AIRWORTHINESS DIRECTIVES FINAL RULES: 97-01-01 R1

SUBJECT HEADING: Airworthiness Directives; The New Piper Aircraft, Inc. PA-24, PA-28R, PA-30, PA-32R, PA-34, and PA-39 Series Airplanes

ACTION: Final rule

Figure 1

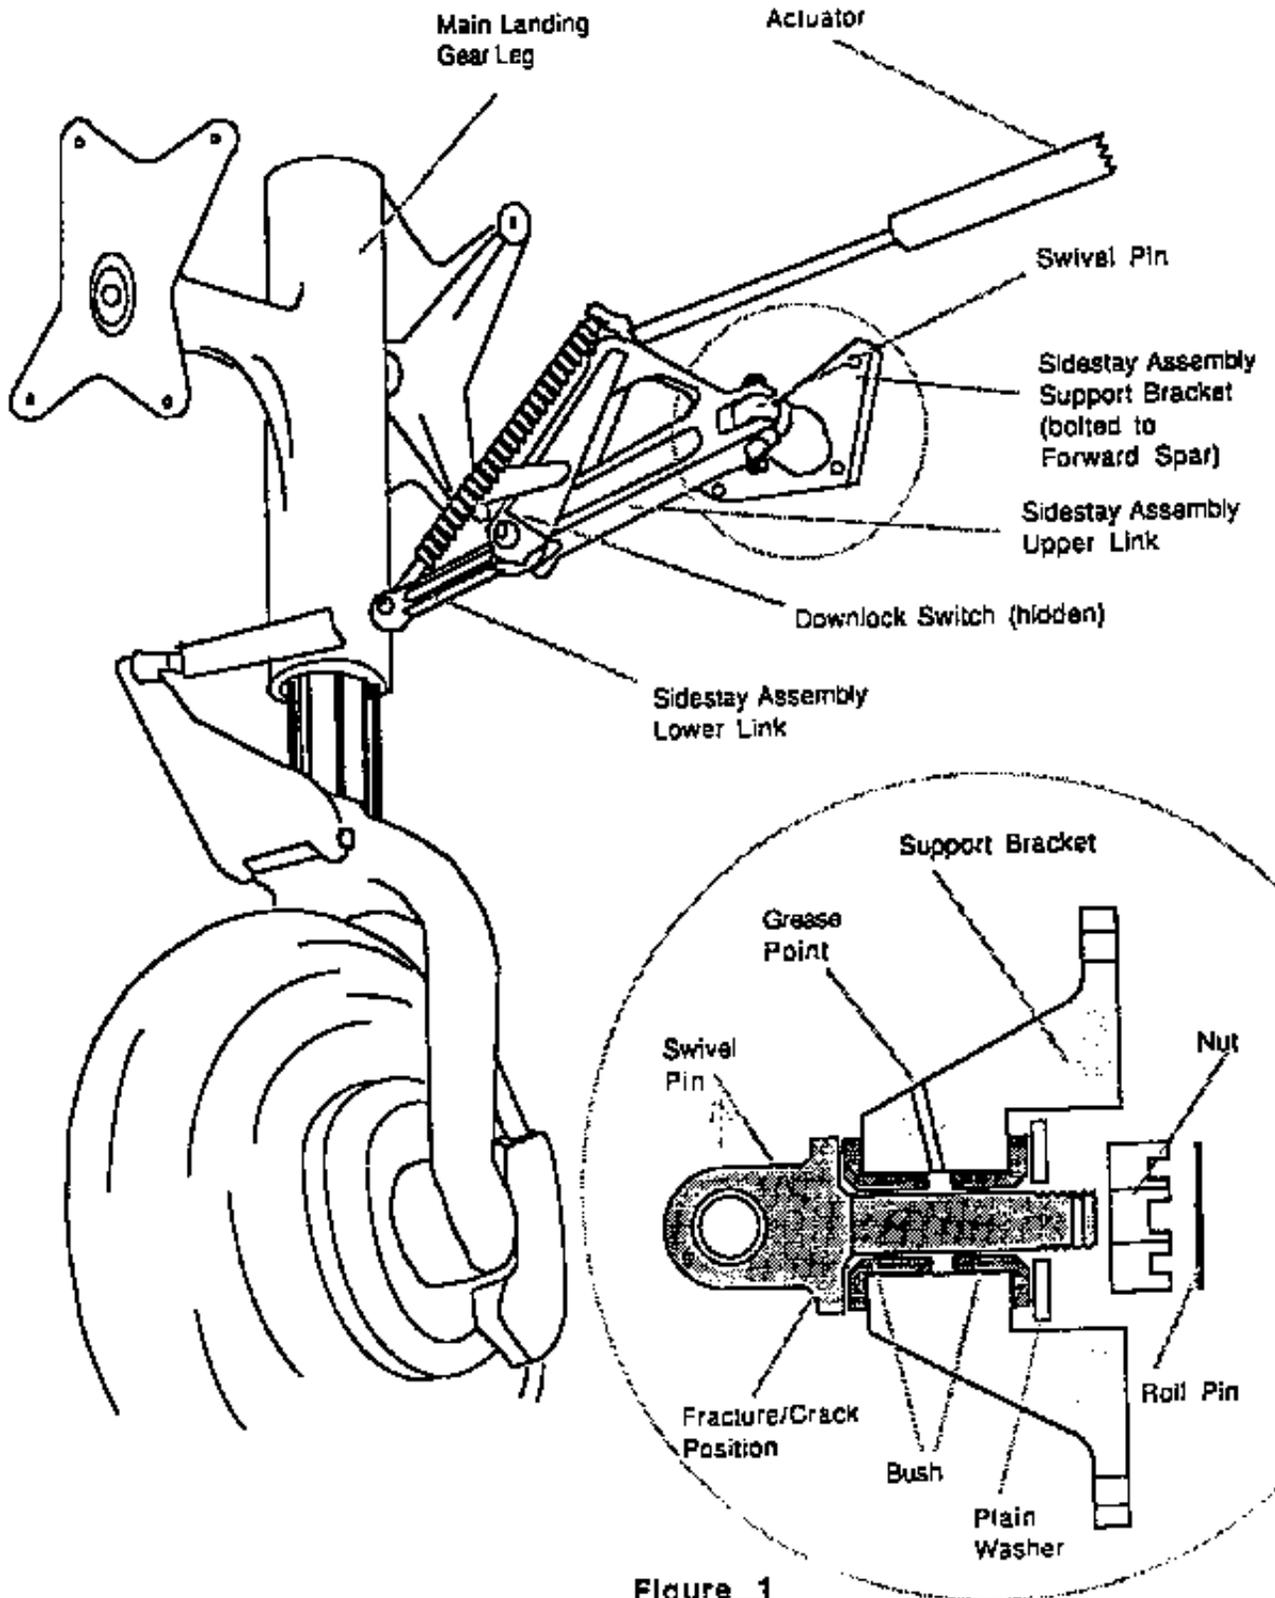
(a) Remove both the left and right main gear sidebrace studs from the airplane in accordance with the instructions contained in the Landing Gear section of the maintenance manual, and inspect each main gear sidebrace stud for cracks, using Type I (fluorescent) liquid penetrant or magnetic particle inspection methods. Figure 1 of this AD depicts the area of the sidebrace stud shank where the sidebrace stud is to be inspected.
